CITY OF ALBUQUERQUE

**Re: Lot 4 Block 6 Unit 18 Volcano Cliffs, S.A.D. 228
6616 Kimmick Dr. NW
Request Permanent C.O. – Accepted
Engineer's Stamp dated: 12-23-2019 (D10D003M4)
Pad Certification dated: None
CO Certification dated: 1/26/2021**

CANDELARIA - GONZALES - GRADING & DRAINAGE PLAN

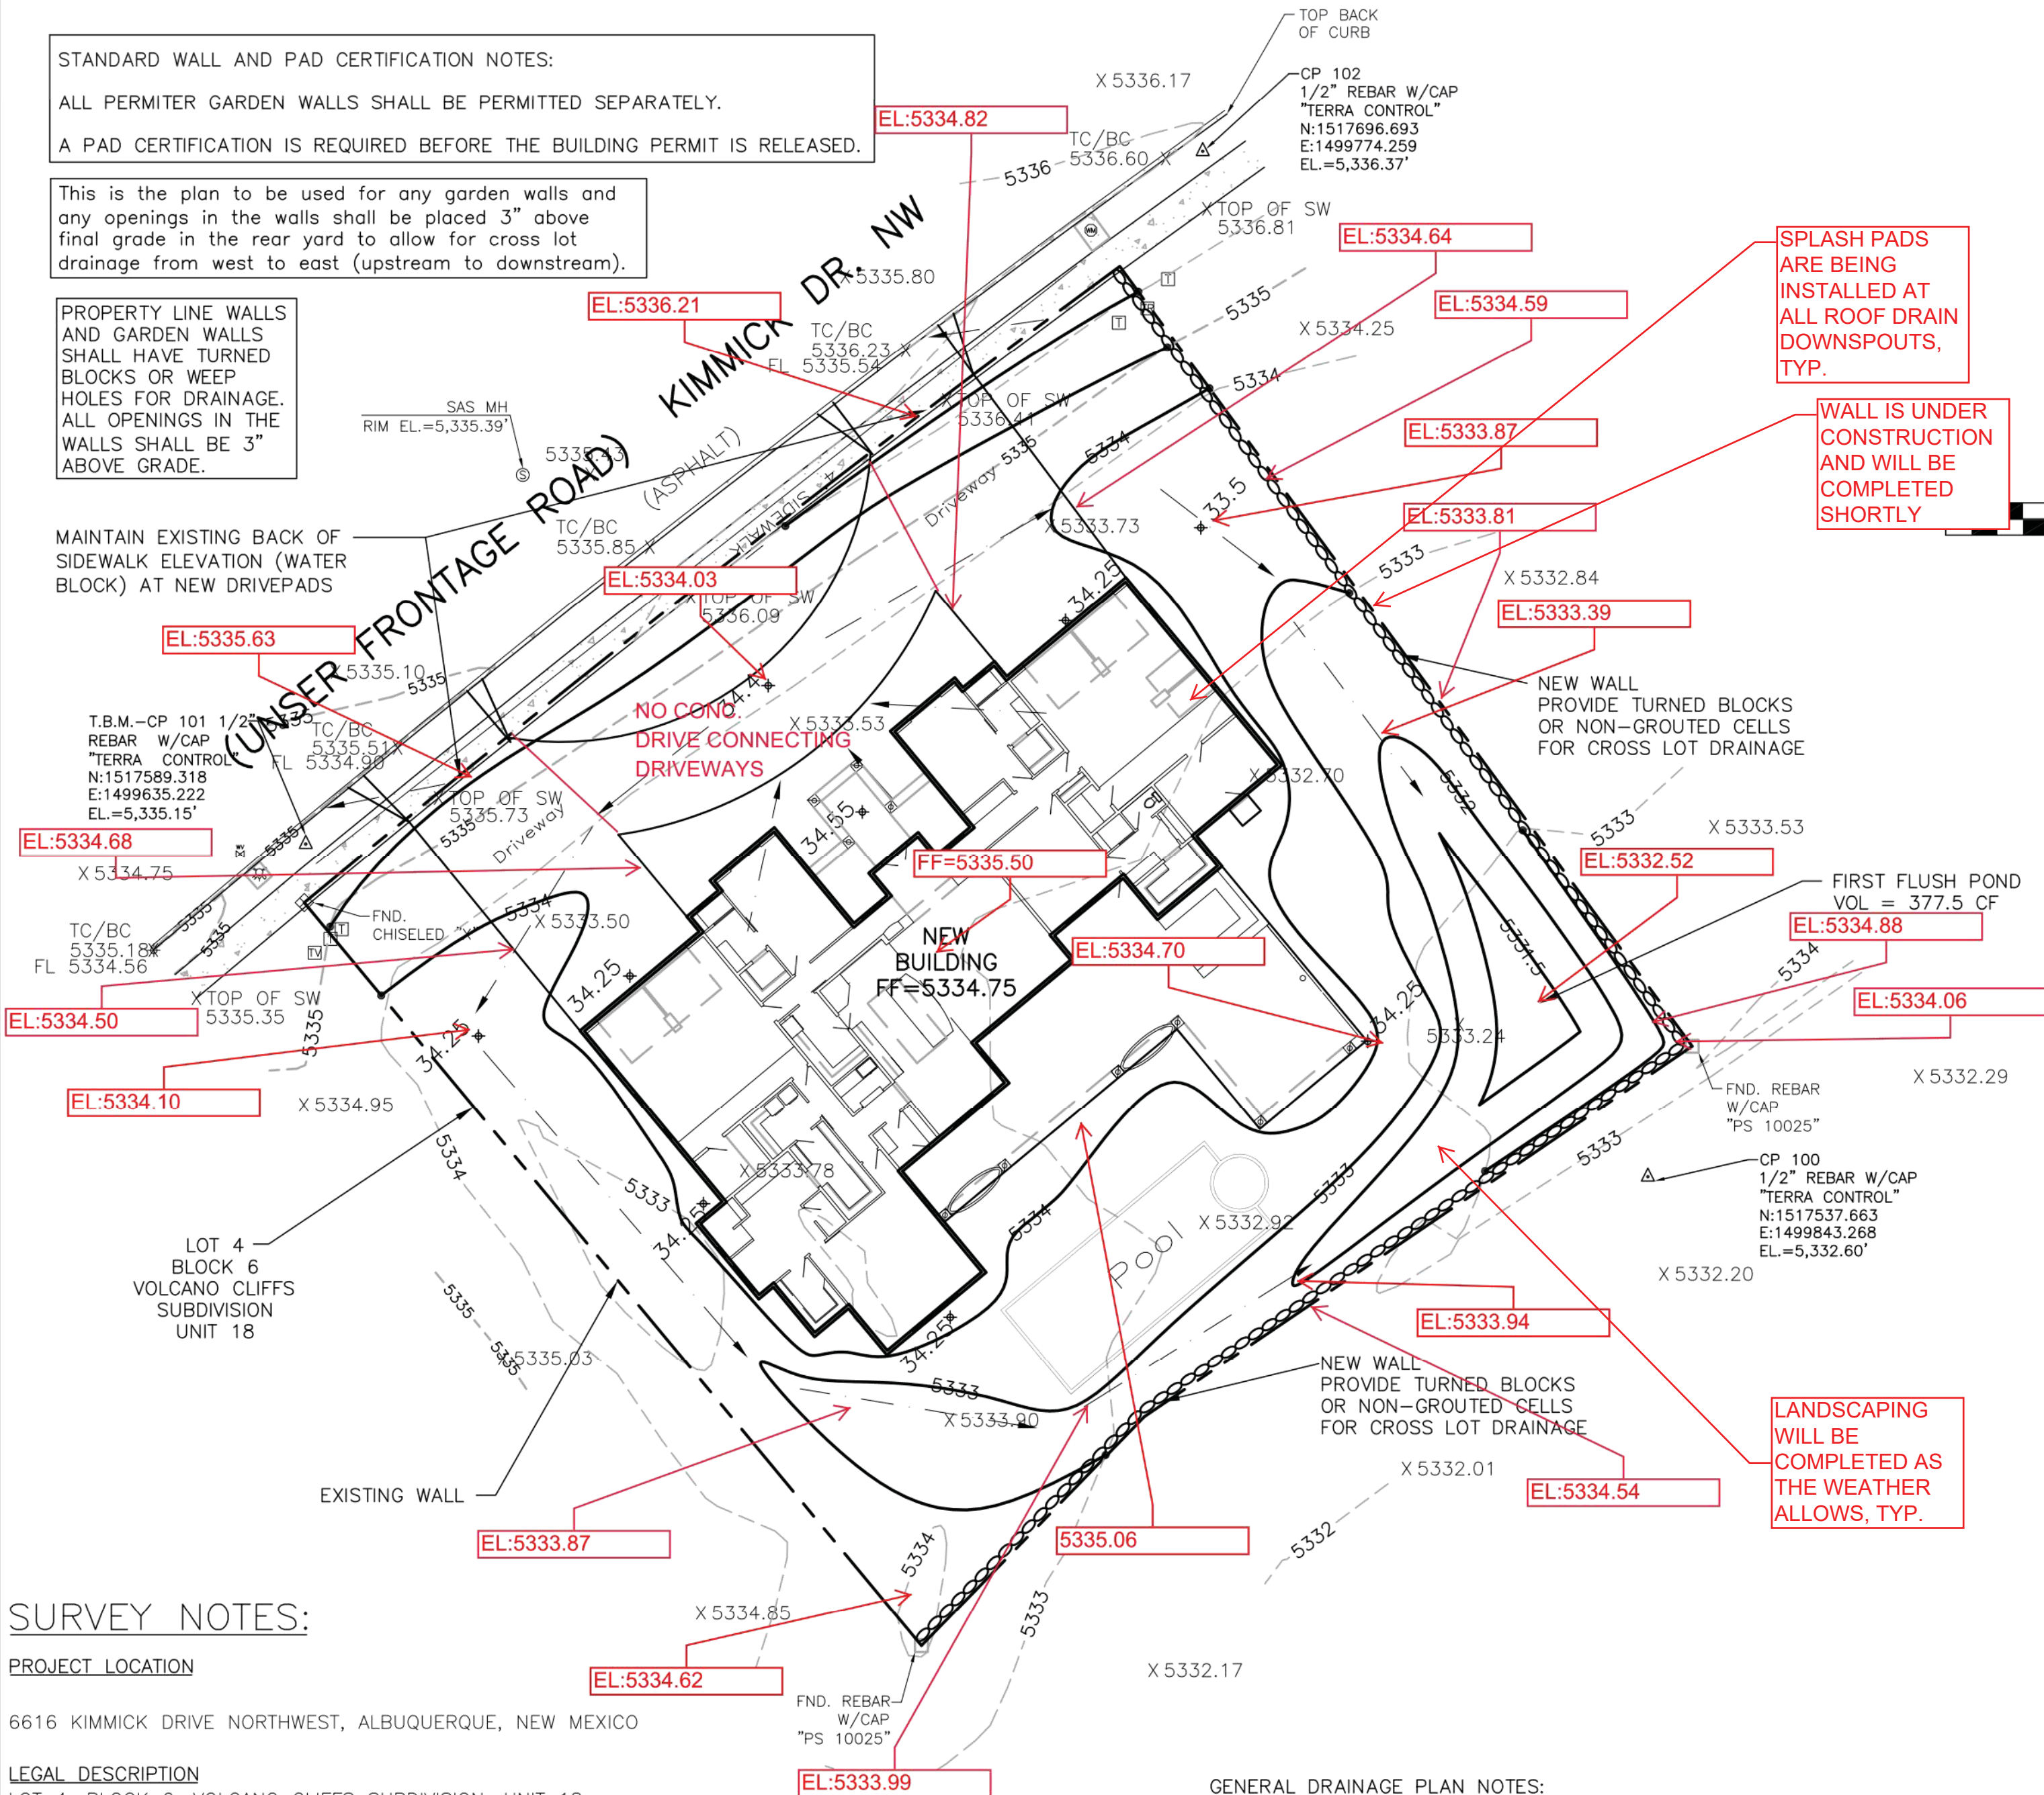
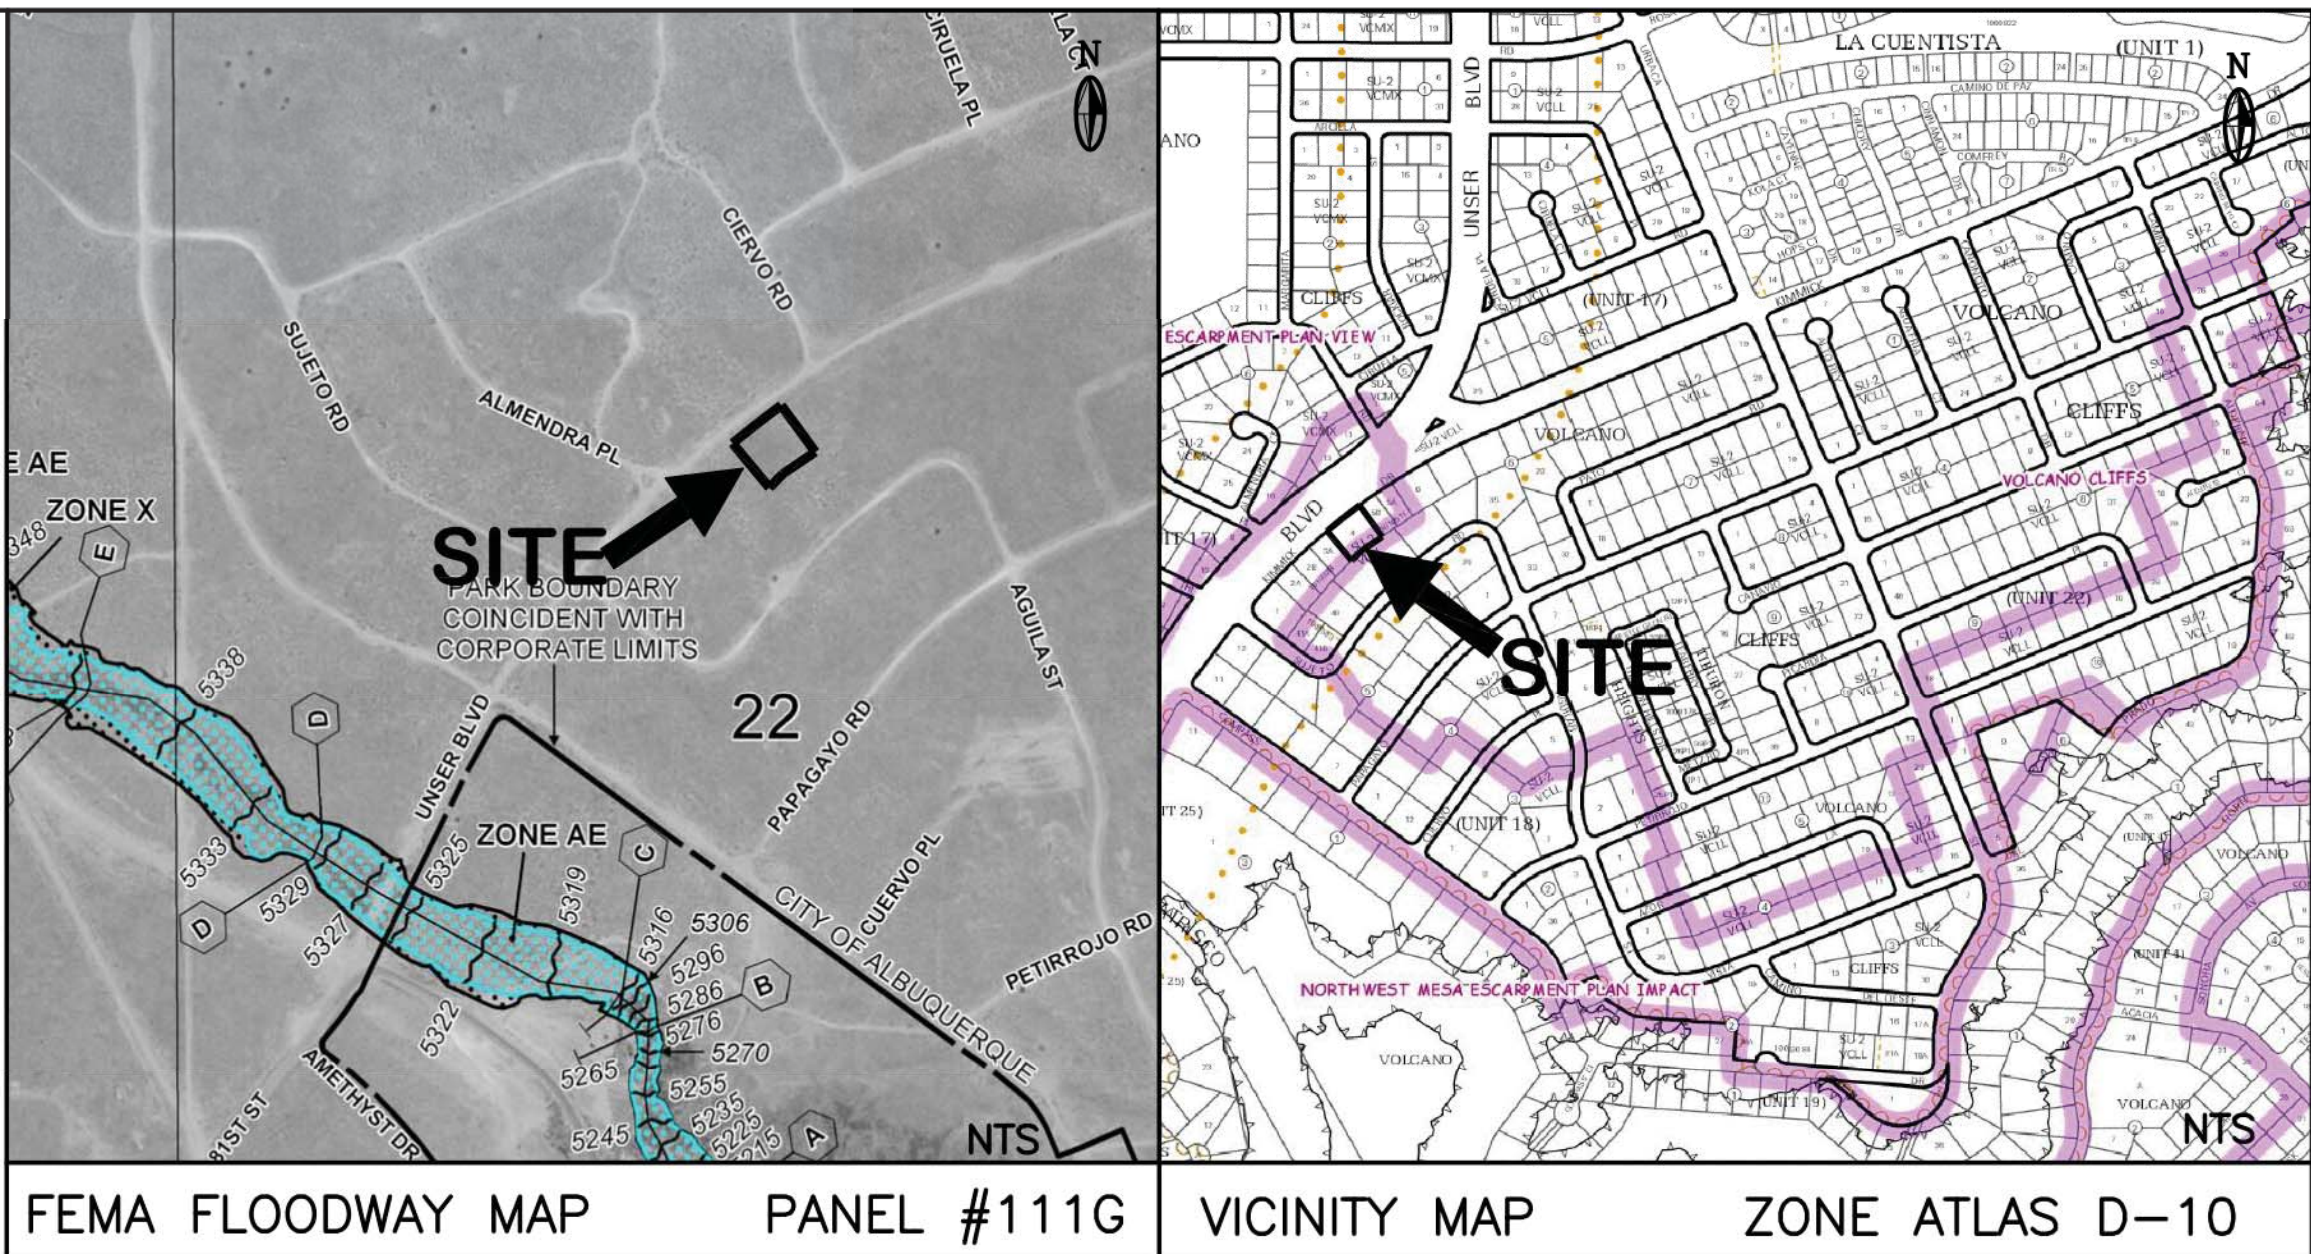
Based on the Certification received 1/28/2021 and supplemental photos received 2/3/2021, the site is acceptable for release of Certificate of Occupancy by Hydrology.
